Sub Regional RTEP Committee PJM Mid-Atlantic Reliability Update

February 16, 2023

Second Review and scope change

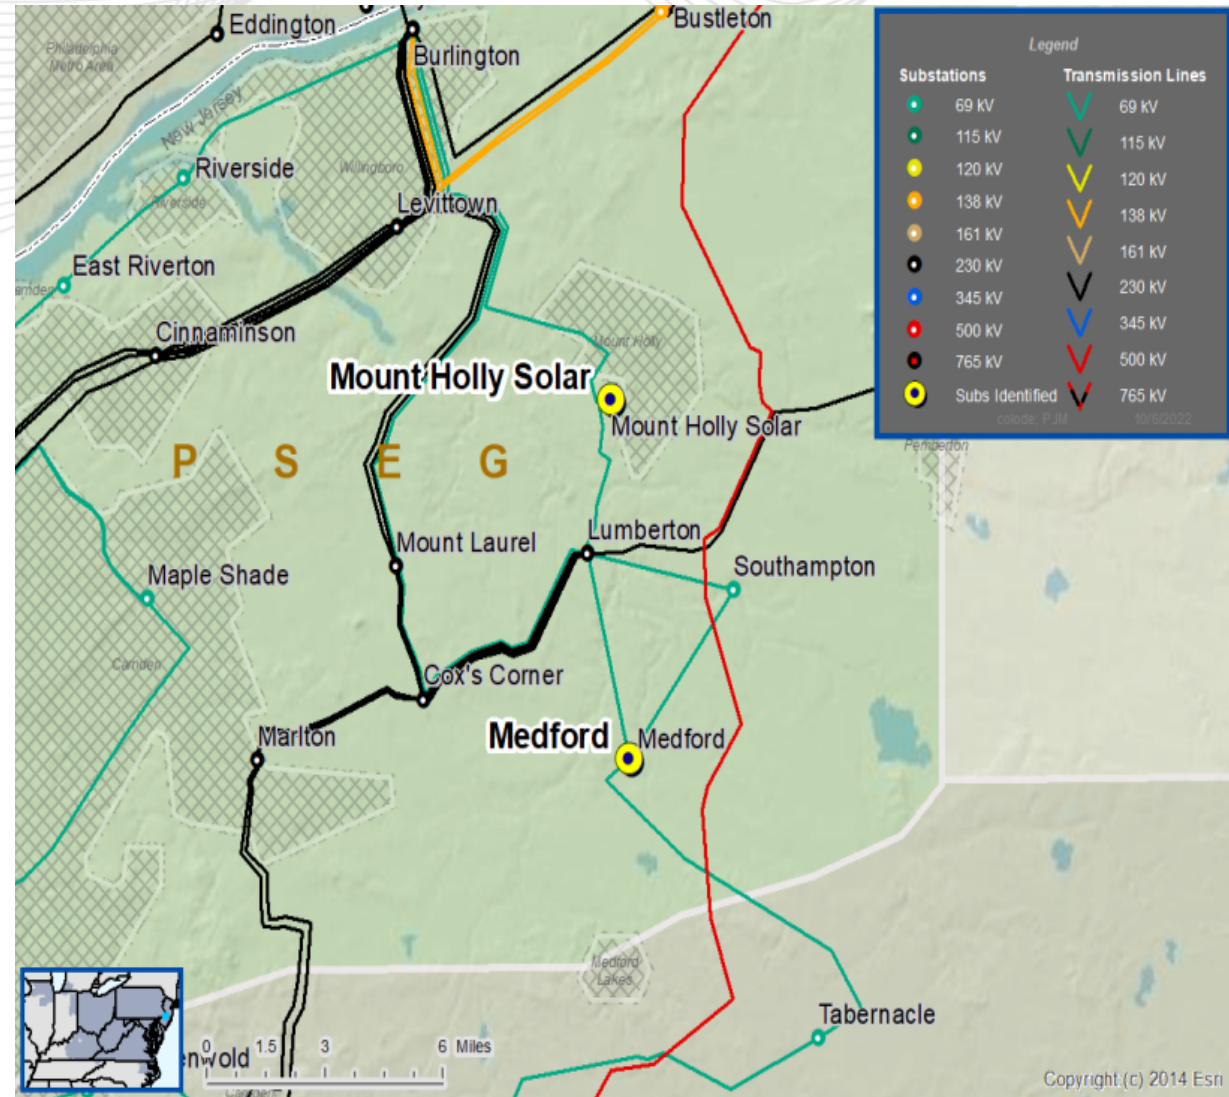
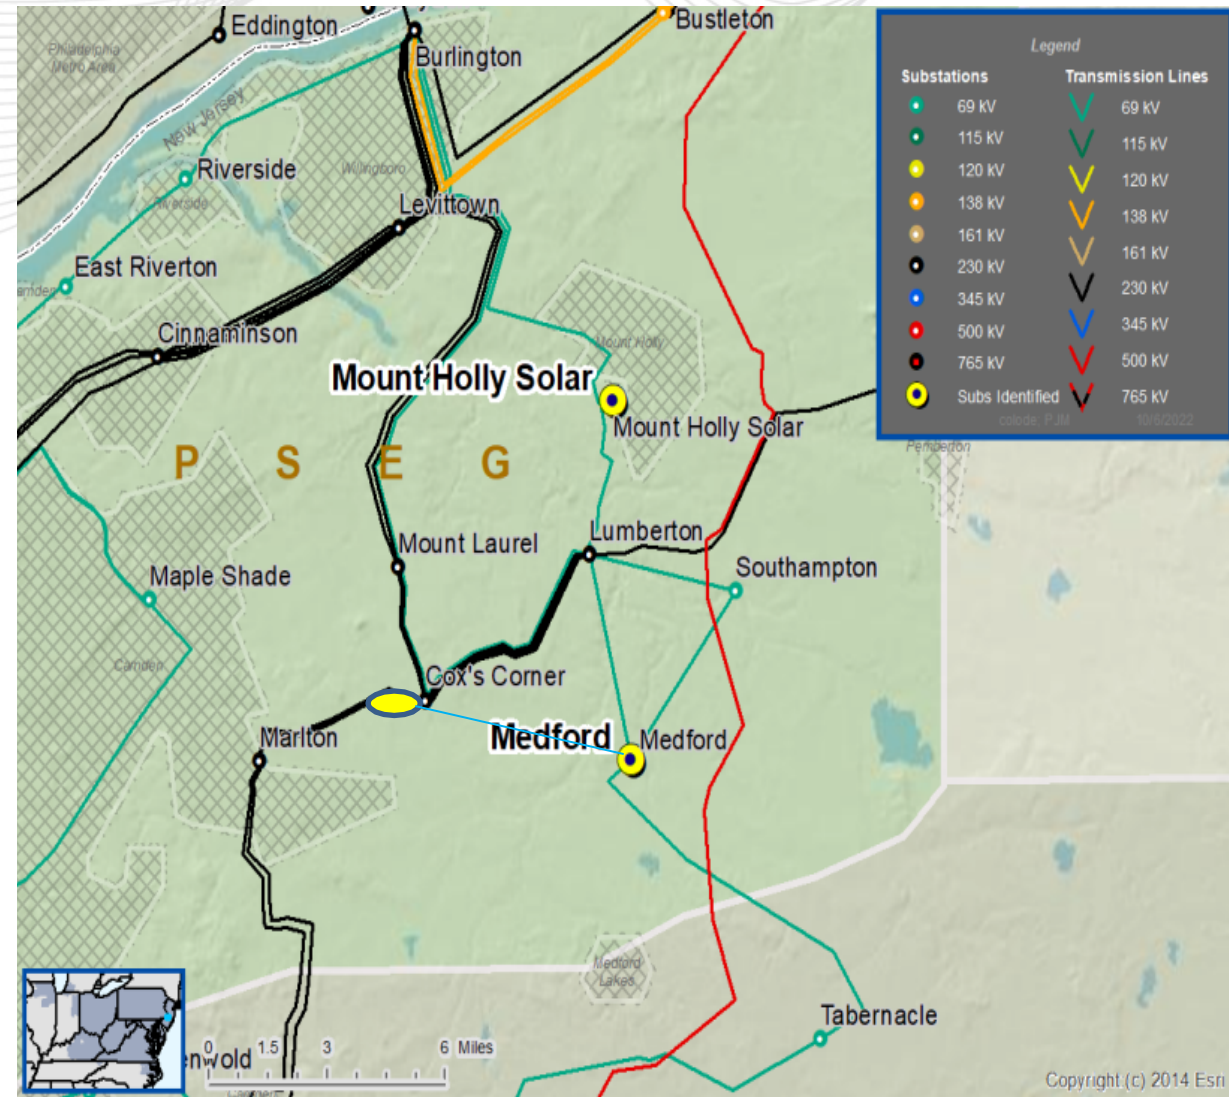
Problem Statement: Voltage drop violation at Medford and South Hampton 69 kV stations for several N-1-1 contingencies.

Convert existing Medford 69kV Straight bus to Seven breaker ring bus, construct a new 69kV line from Medford to the Mount Holly station, and install a capacitor bank at Medford.

- Current straight bus design at both stations cannot accommodate connection of capacitor banks in the appropriate locations to address all contingencies. Reported voltage drop is too great for capacitor banks at each location to be an effective solution.

- circuit to Maple Shade has approximately seven extra miles and an additional highway crossing.

Convert existing Medford 69kV Straight bus to Seven breaker ring bus, construct a new 230/69kV transformer at Cox's Corner and a new line from Cox's Corner to Medford. (b3757)
